STATE OF MAINE  
 DEPARTMENT OF TRANSPORTATION  
 16 STATE HOUSE STATION  
 AUGUSTA, MAINE 04333-0016

October 8, 2021  
 Subject: Station 46 Bridge Replacement &  
 Pleasant Cove Bridge Replacement  
 State WINs: 023929.00 & 023929.01  
 Location: **Woolwich**  
**Amendment No. 3**

**ADD** the attached “Conceptual ACOE Impact Plan Pleasant Cove Bridge\_10-1-21”, 3 pages.

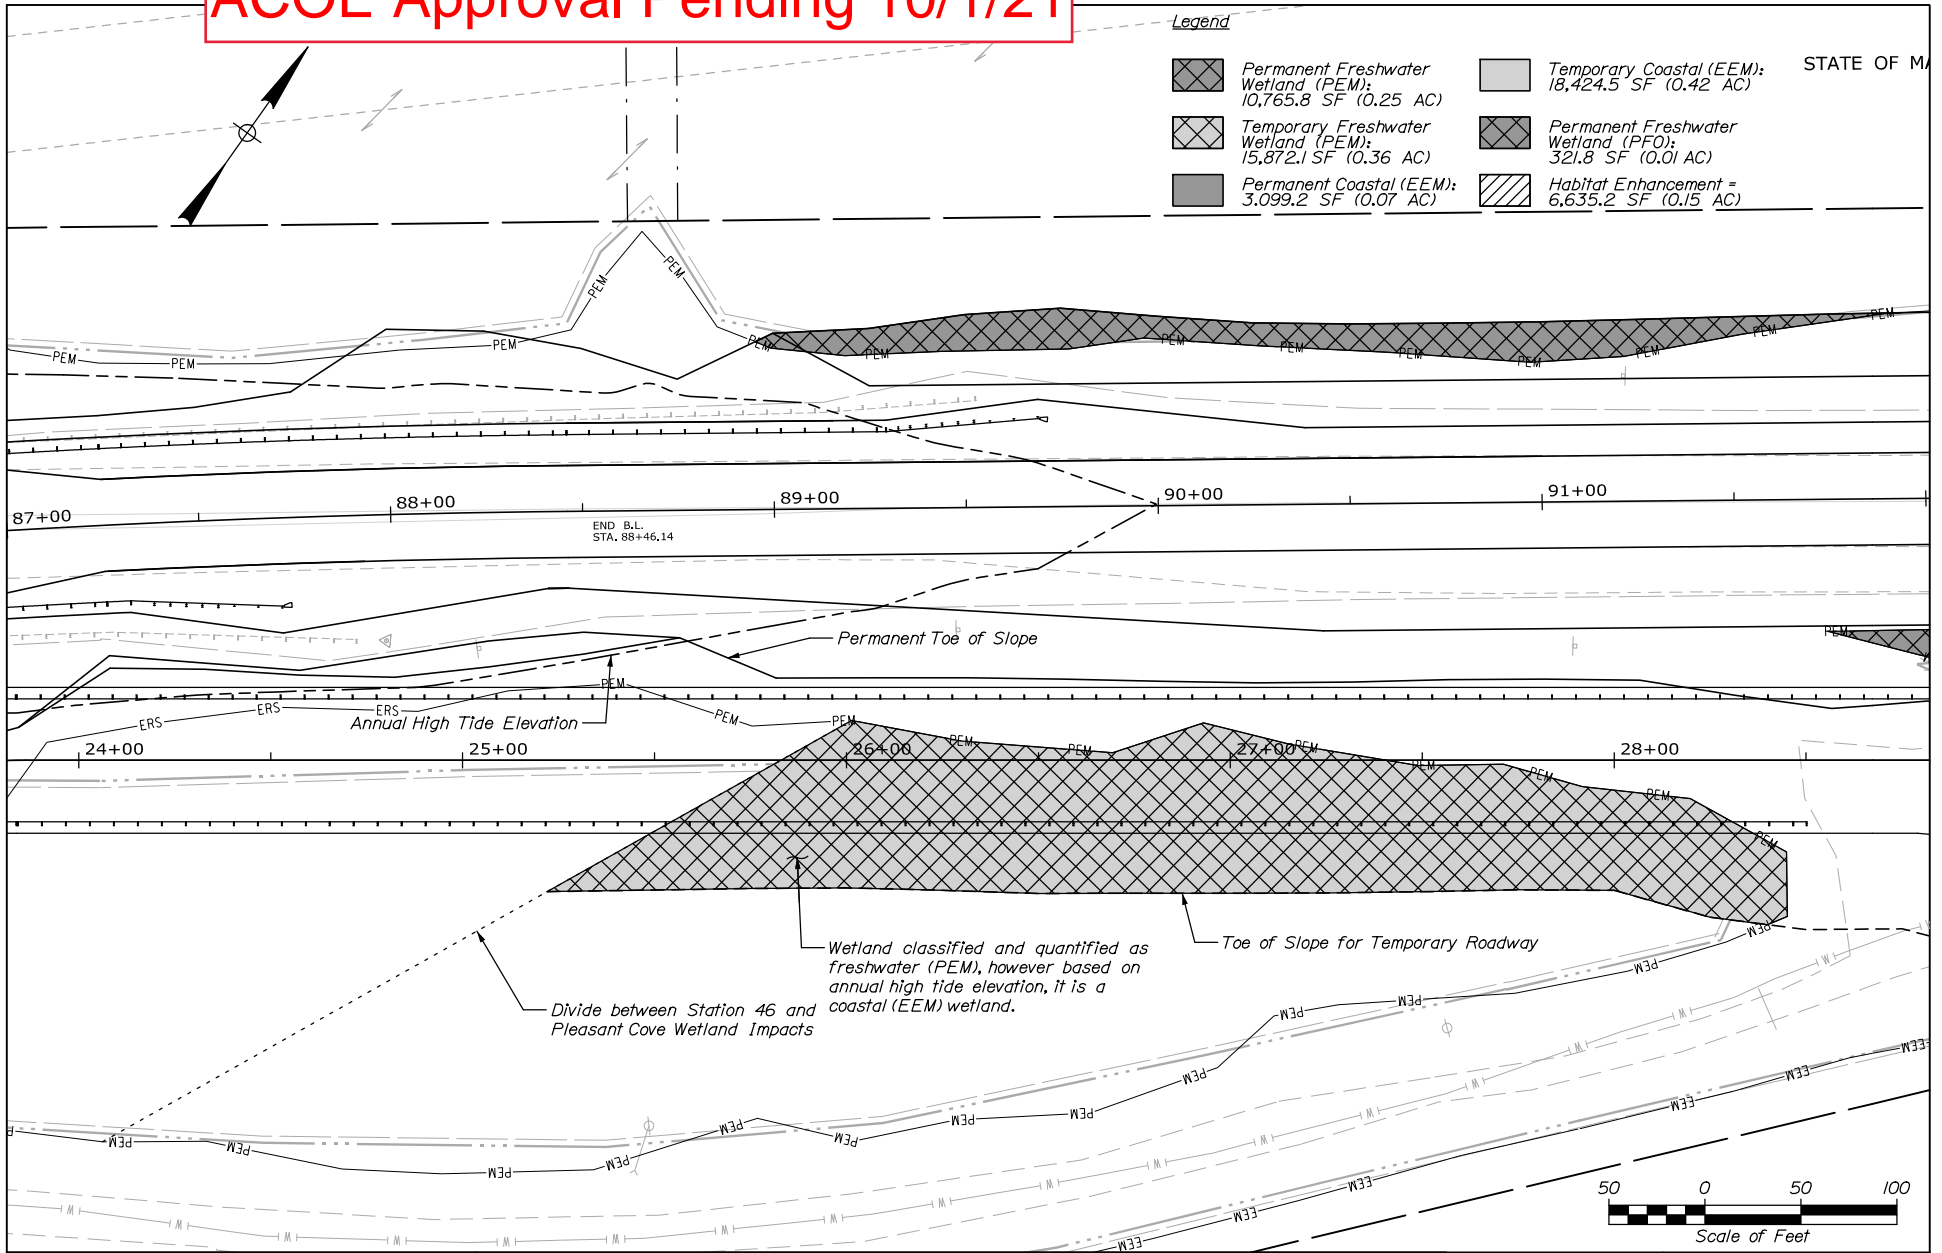
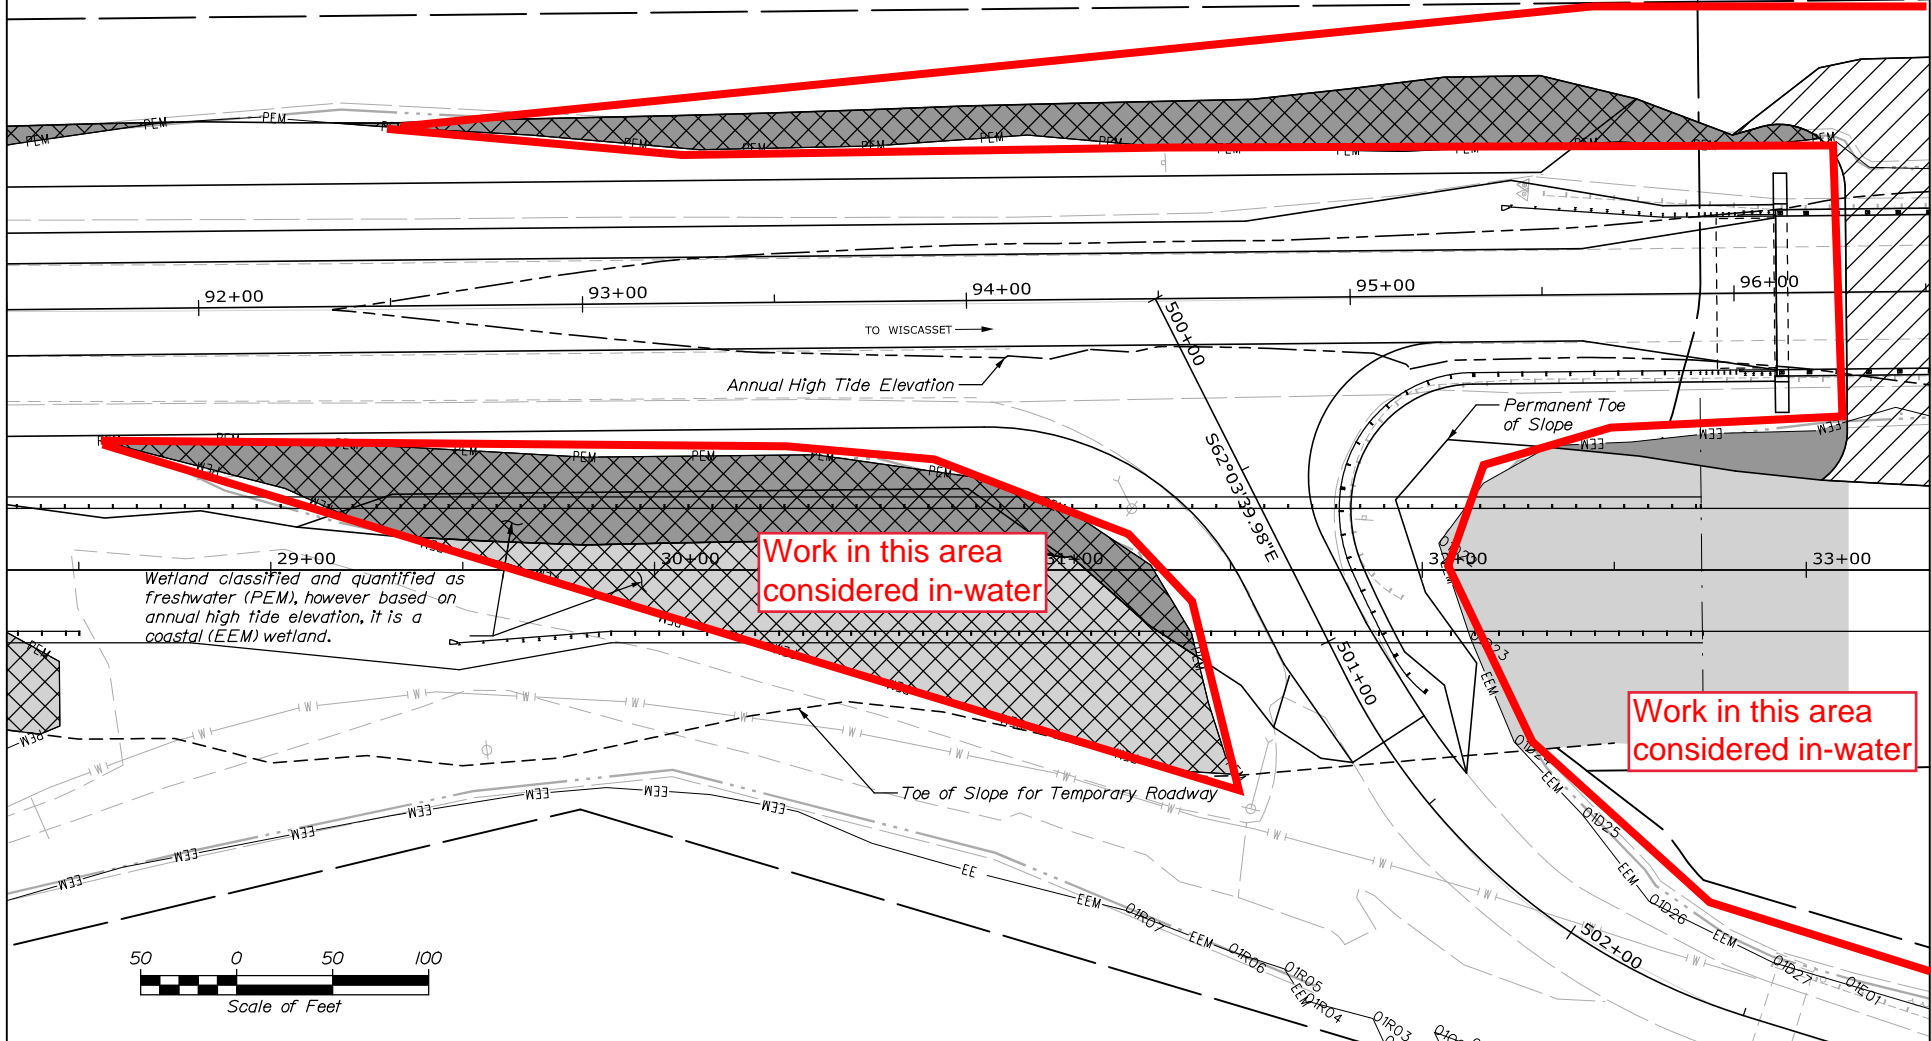
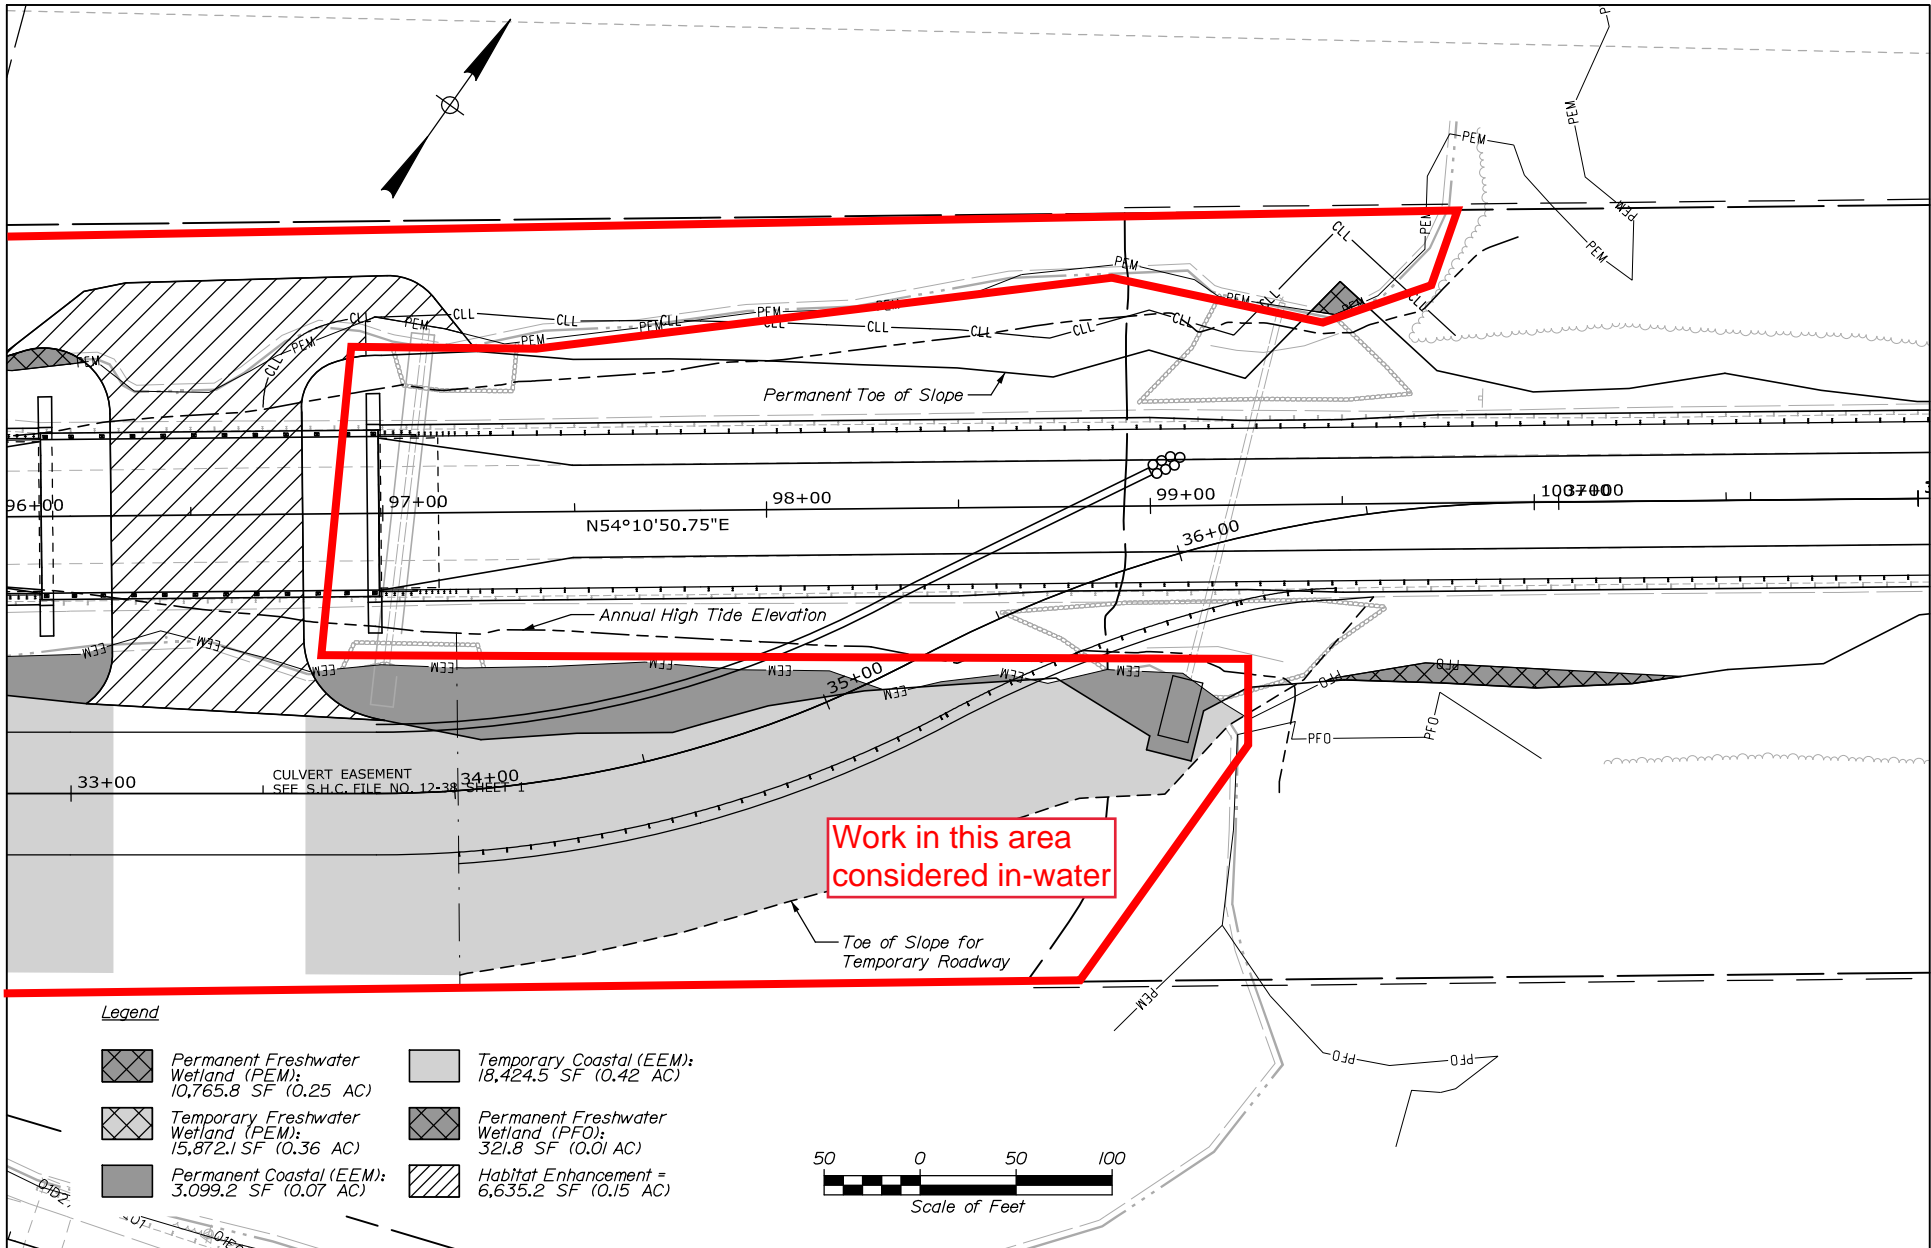
**Question:** Similar to what was provided for the Station 46 Bridge, please provide a plan sheet for Pleasant Cover bridge showing the shaded impact areas and designation line of in-water work.

**Response:** Please see attached "Conceptual ACOE Impact Plan Pleasant Cove Bridge\_10-1-21." In-water window is applicable to all work completed within the areas designated in red.
